FINAL DRAINAGE REPORT

TRAILS AT ASPEN RIDGE Filing No. 3

April 2021

SF-21-002

DATE ISSUED: MARCH 2021
SHEET NO. 2 OF 3 SHEETS

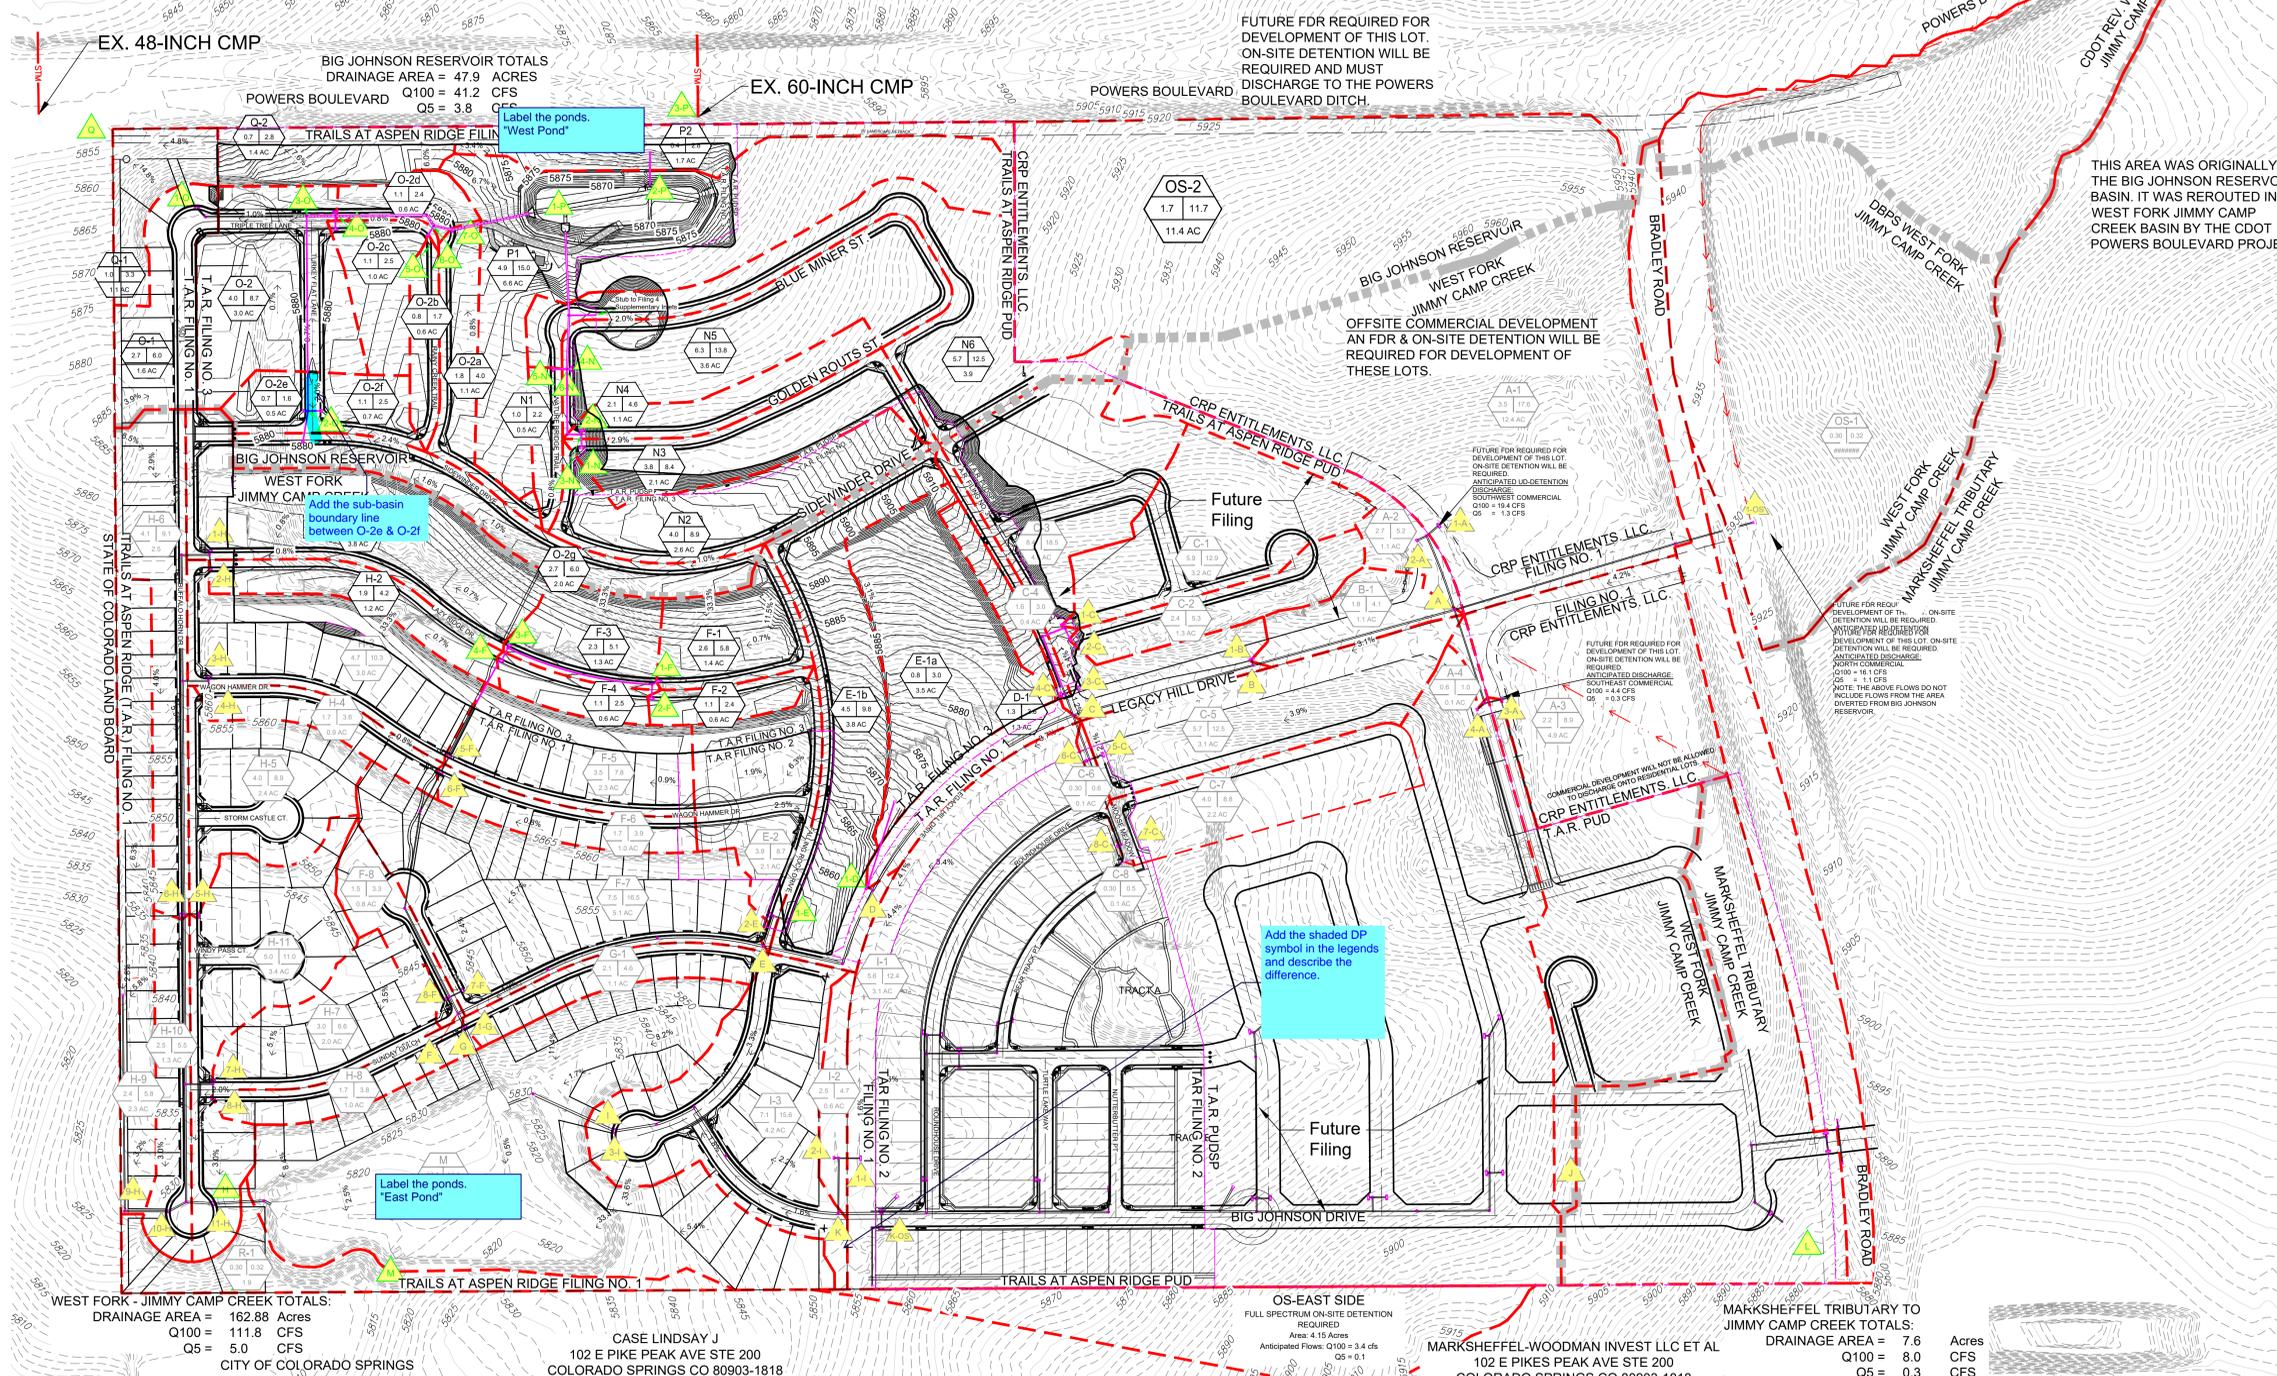
Provide a more detailed title like "Proposed Drainage Conditions"

Revise so that structure names match those in schematic maps. This applies to all pages.

DESIGNED BY: JTS SCALE: DATE ISSUED: APRIL 2021
 DRAWN BY: JTS HORIZ: SHEET NO. 3 OF 3 SHEETS
 CHECKED BY: VERT: DR-03

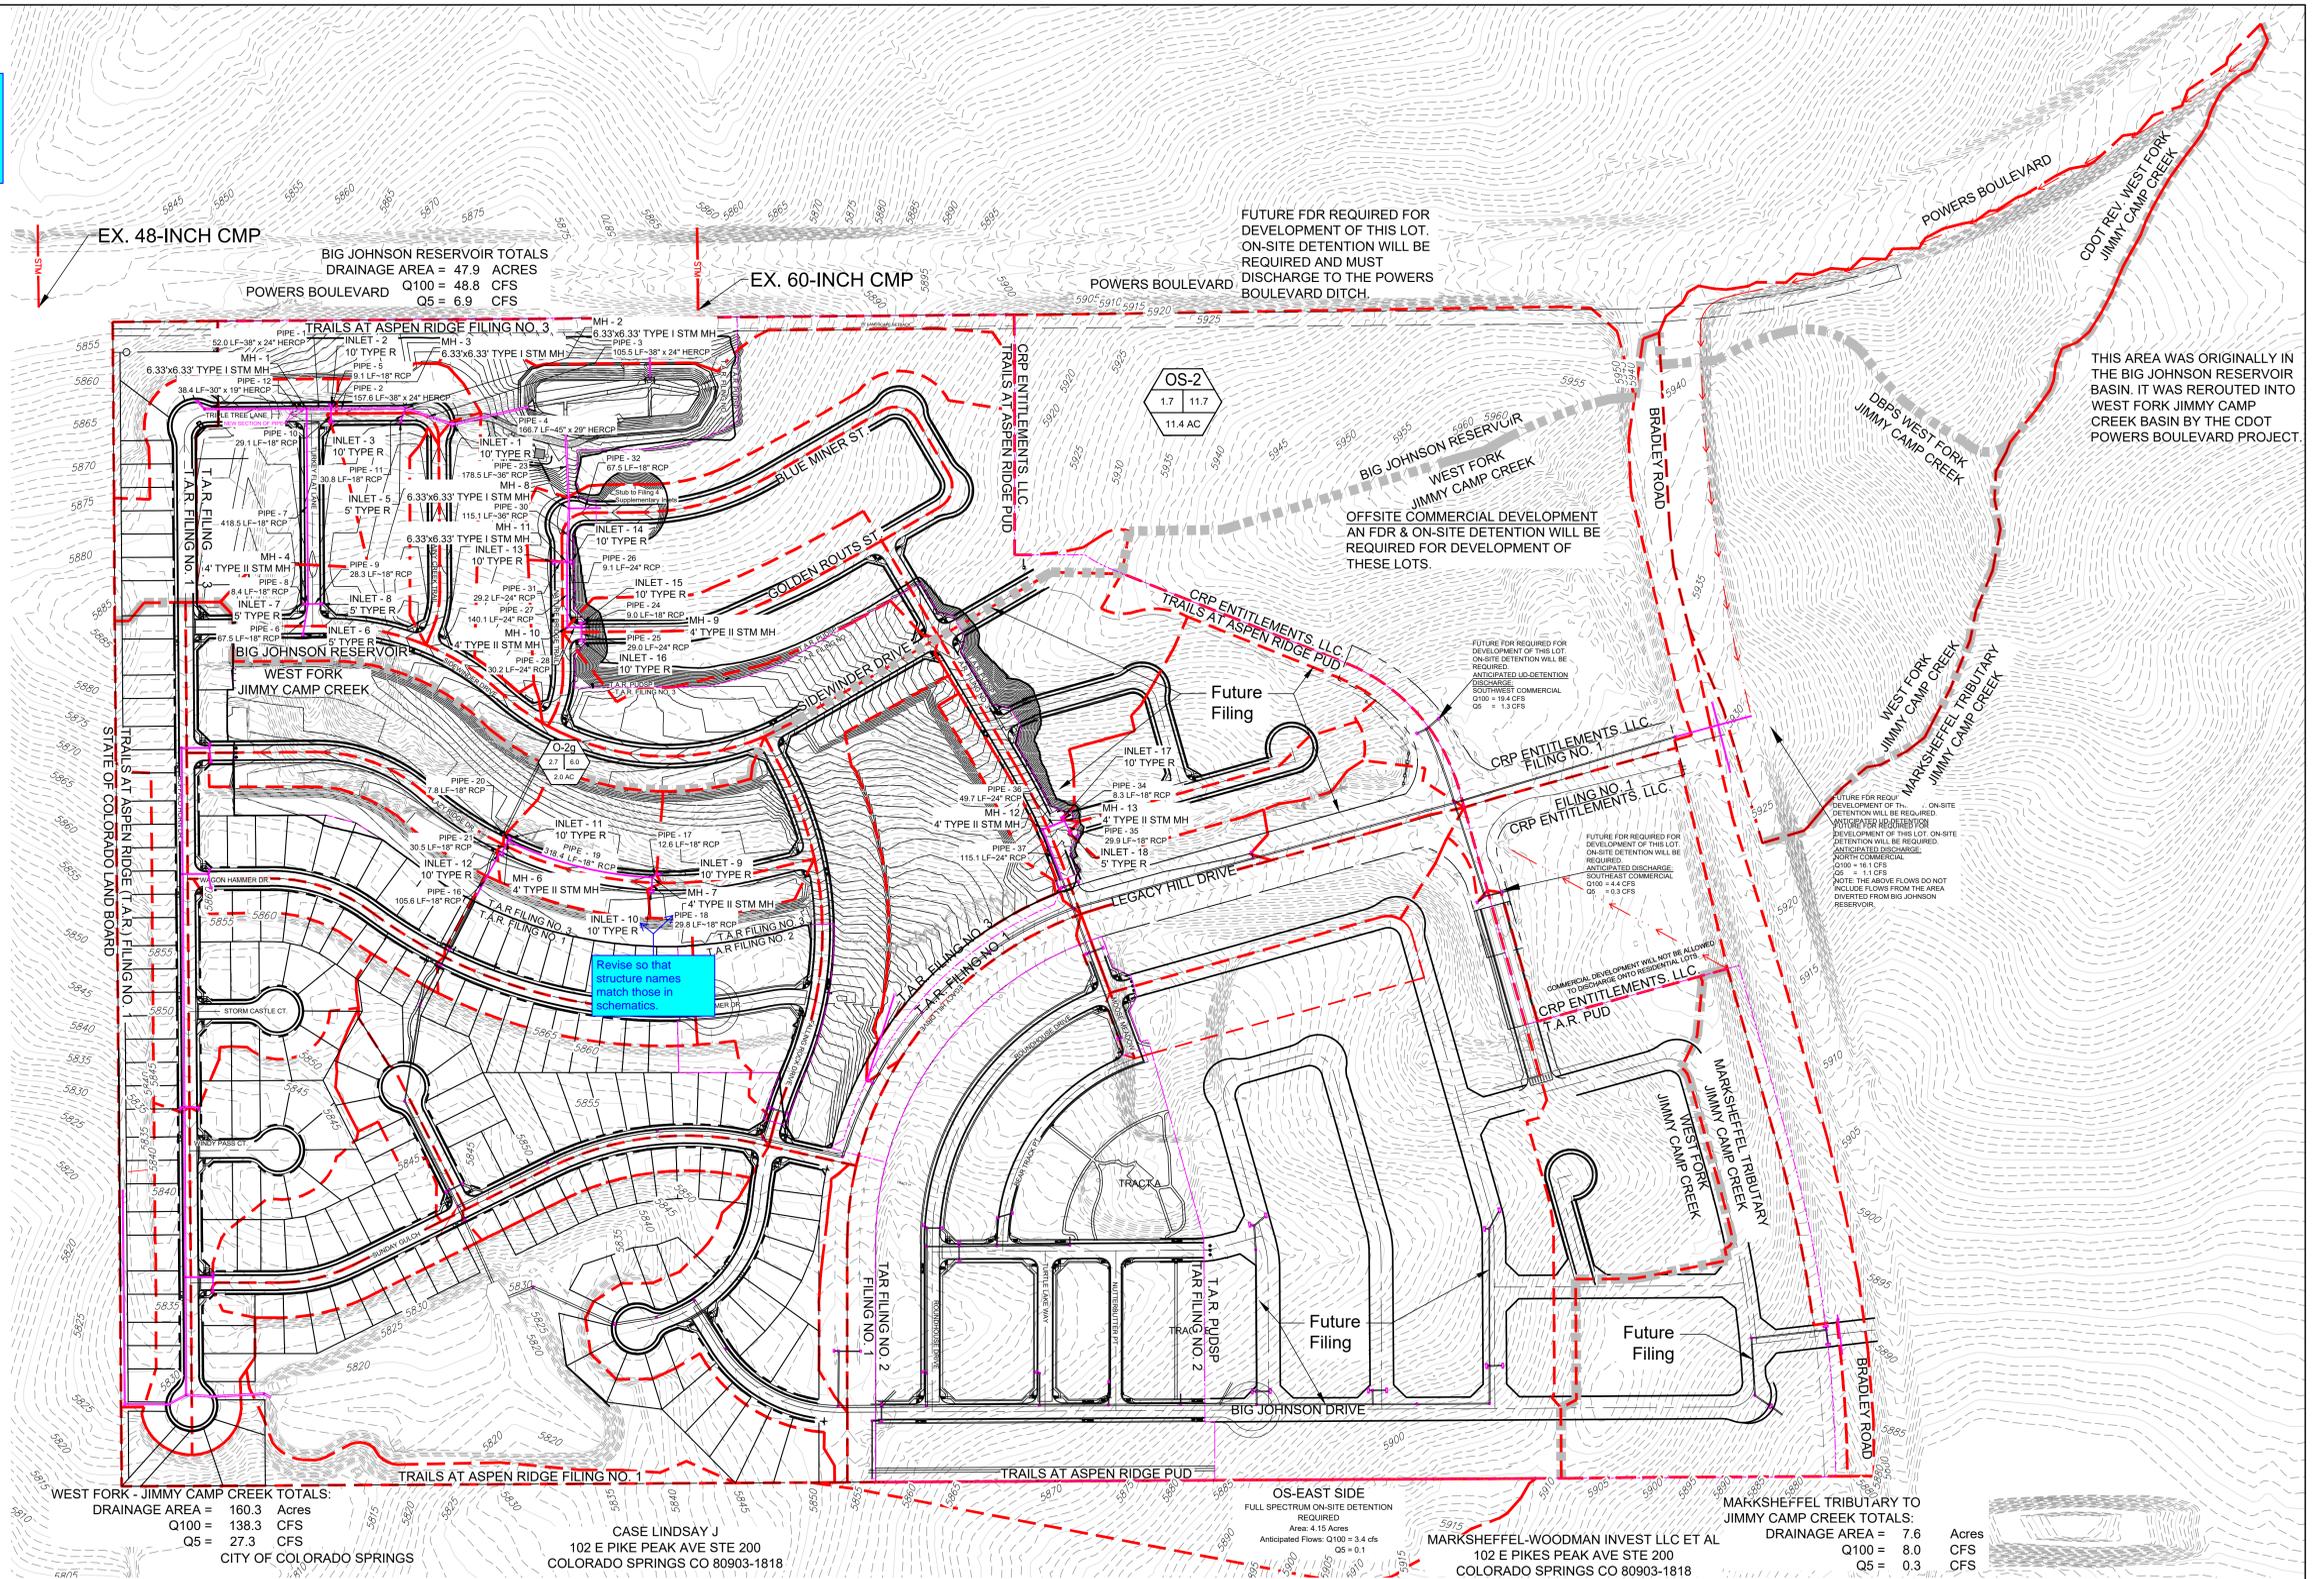
Provide a more detailed title like "Proposed Drainage Conditions"
